Comments on the Groundwater Technical Impracticability Evaluation for Butte Priority Soils Operable Unit

**Prepared by
Citizens Technical Environmental Committee (CTEC) Of
Butte, Montana**

August 9, 2005

Figure 1: LAO Arsenic Concentration Trends

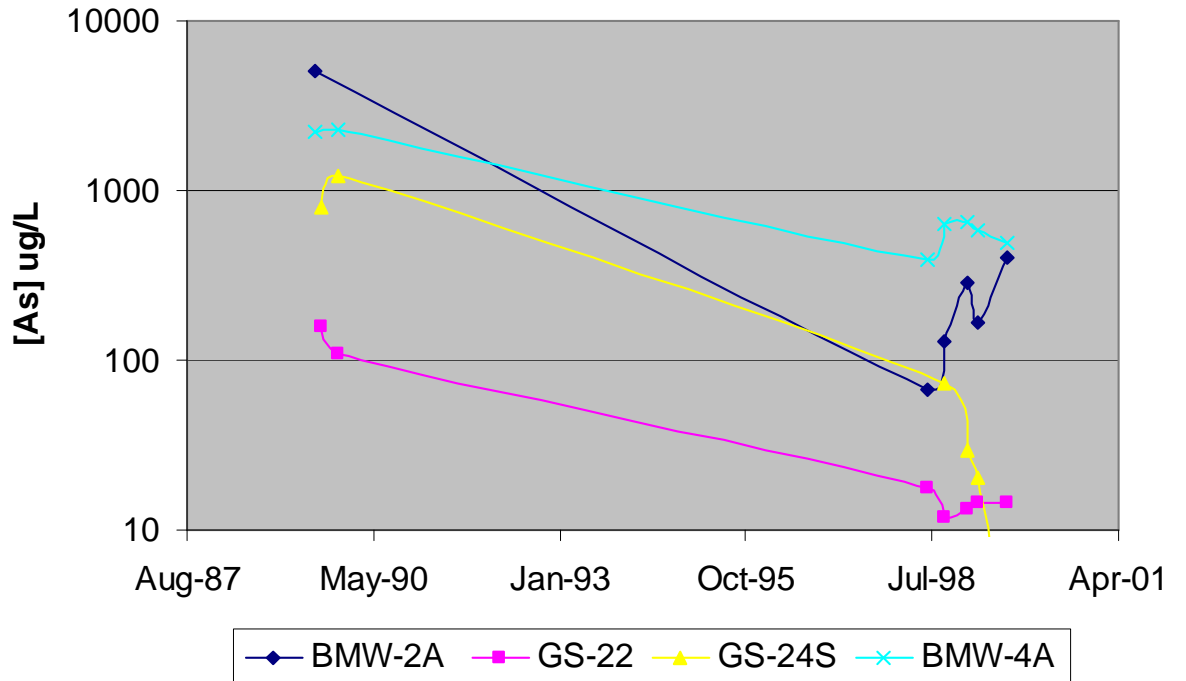
- Water quality data from table 9 for selected wells located at LAO is presented in figures 1 and 2 below. Figure 1 shows arsenic concentration

over time for wells that had high arsenic concentration in 1989 (ie: contaminated wells). Figure 1 clearly shows great improvements in water quality since removal of tailings at LAO commenced in 1993 and was completed in 1997. Arsenic concentrations in two wells have improved 2 orders of magnitude (note figure 1 has a logarithmic scale) and have improved at least one order of magnitude in all wells. Figure 2 shows copper concentration over time for wells that had concentrations of copper exceeding 12000 ug/L in 1989. Copper concentration in all wells show improvement since the 1989 sampling event and currently all wells are experiencing improving water quality. The water quality improvements seen at LAO underscores the fact that dramatic improvements in water quality are quickly realized even under partial removal of source areas (1.2 million cu yd of a total of 2.2 million cu yd of identified COC source material has been removed at LAO). Two wells in figure 2 show dramatic improvements in water quality by 1998, one year after the partial tailings removal was completed.

3.16 Section 3.3.2.2 Aquifer Recovery of Lower Area One; 3.3.2.3 BPSOU Alluvial Aquifer Recovery; 3.3.3 Previous Opinions on Recovery Following Removal; 3.4.3 Remaining Diffuse Sources. CTEC requests that all references to the lack of improvement in water quality at LAO since tailings removal be deleted from these sections. Statements such as “groundwater COC concentration within the BPSOU remain largely unchanged since the SBC Phase II RI even after extensive removal in LAO” in section 3.3.3 are incorrect and misleading. As described in General Comment 2.1 and seen in figures 1 and 2 below water quality is improving since COC source removal.

Figure 2: LAO Copper Concentration Trends

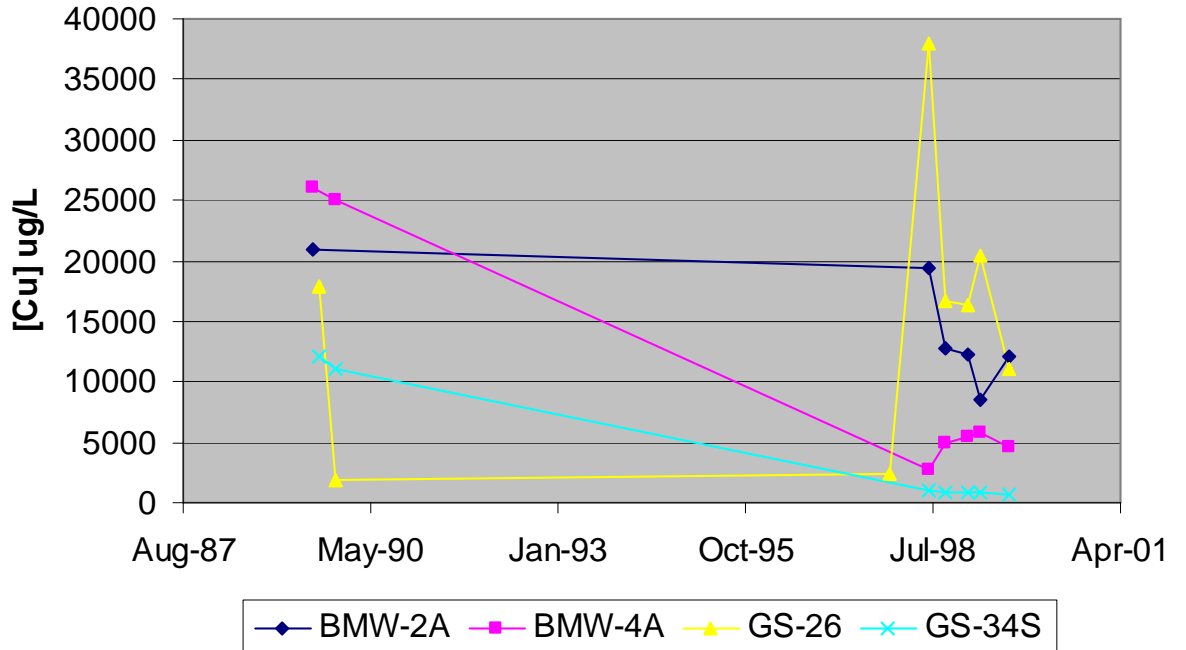
- Copper trends for highly contaminated wells presented in table 9 that do not show an improving trend are located in the Parrott Tailings. We would not expect to see an improving trend in wells completed in the Parrott because no source material has been removed. The text is misleading in presenting Parrott well data and suggesting that the data shows the futility of source removal. The text should more accurately state that if COC sources are left in place in the MSD then water quality should be expected to continue without improvement.
